**Brunswick – Glynn  
Joint Water & Sewer Commission**

**PROJECT:       ENGINEERING, SURVEYING & DESIGN PROPOSALS – HOLLY  
STREET SEWER IMPROVEMENTS**

**ADDENDUM:    One (1)**

BRUNSWICK-GLYNN JOINT WATER & SEWER COMMISSION  
1703 GLOUCESTER STREET, BRUNSWICK, GA 31520  
GLYNN HAVEN - HOLLY STREET GRAVITY SEWER PROPOSAL

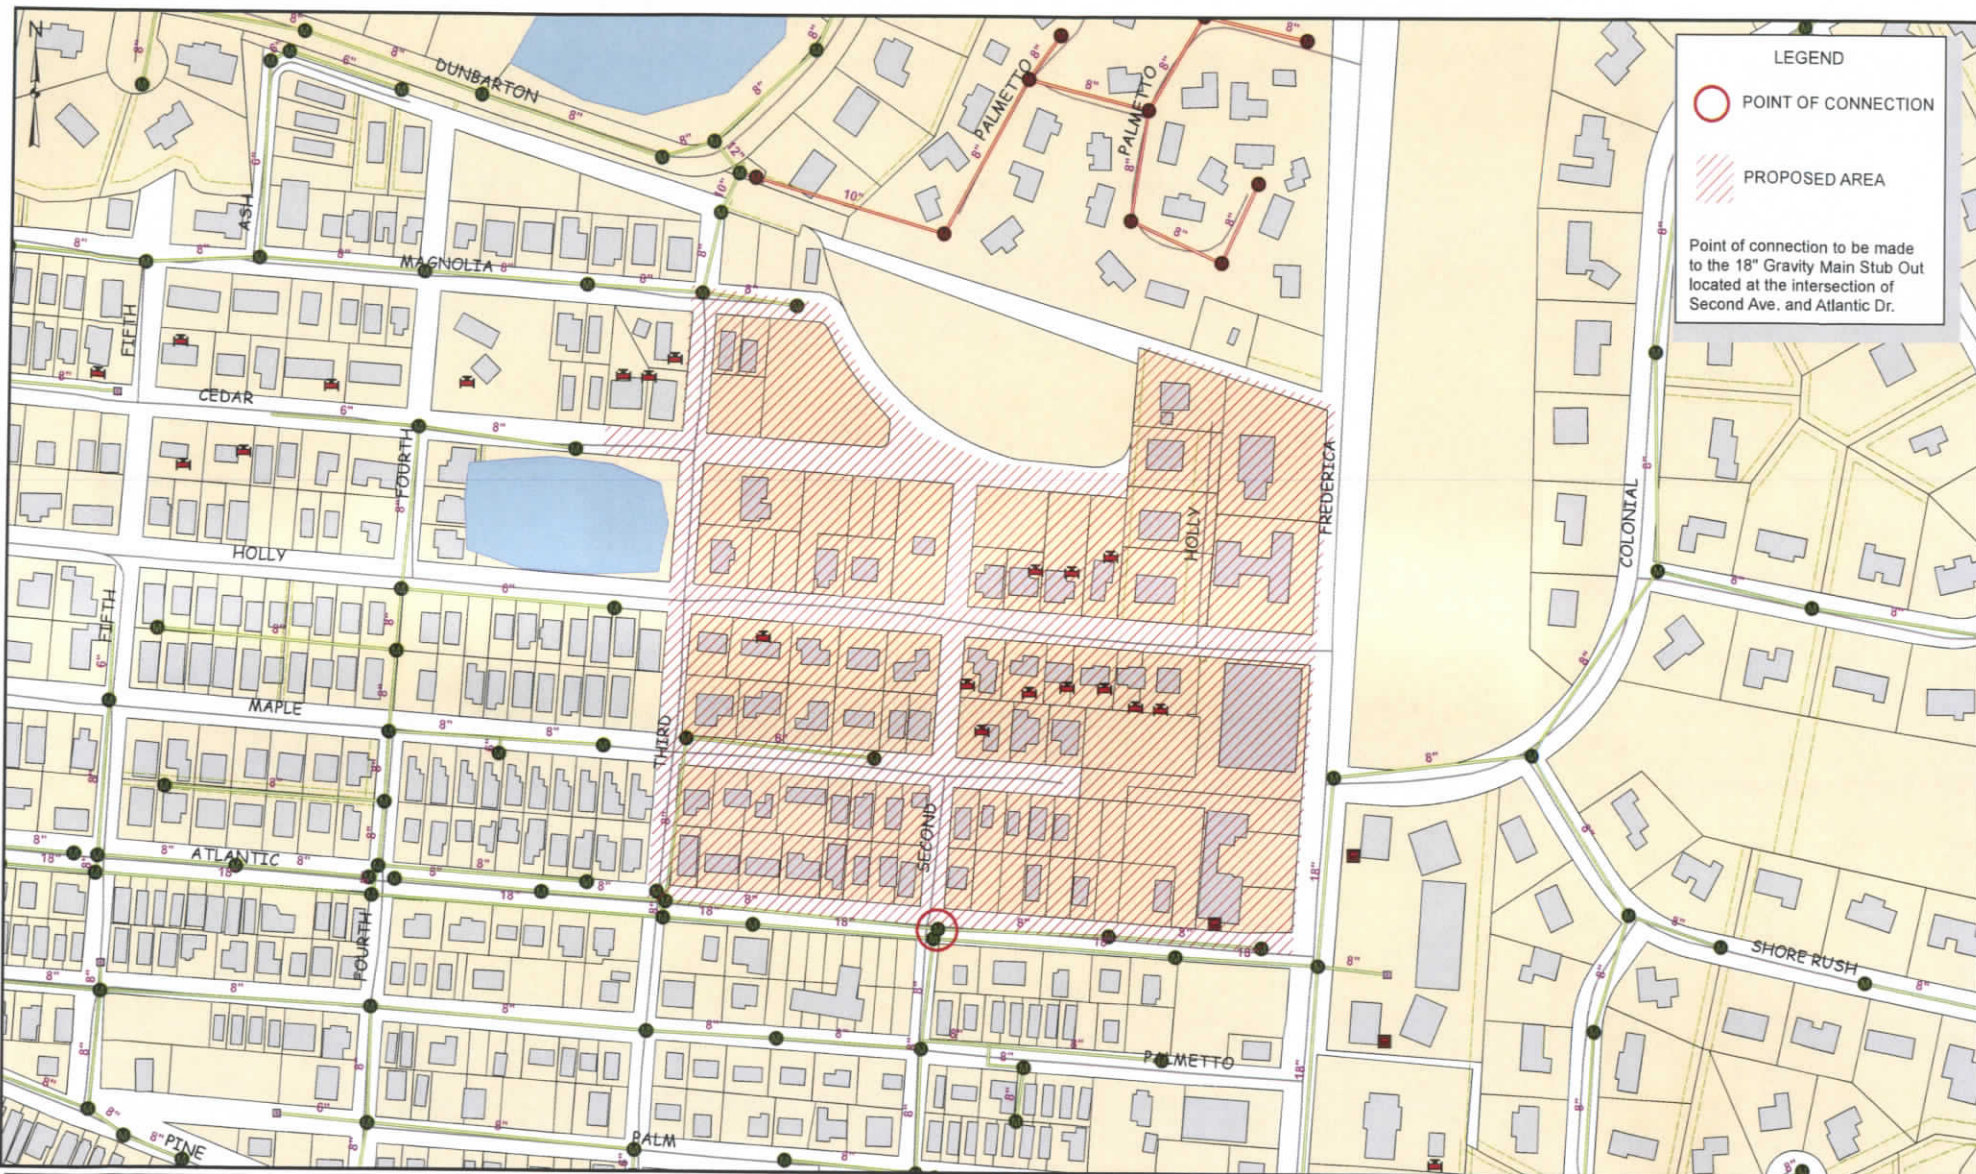
- 8. Map update:**

The map has been revised to show a single potential point of connection, it is upon the Engineer to design a system that will serve the most amount of people with a gravity system. Other connection points may be acceptable.
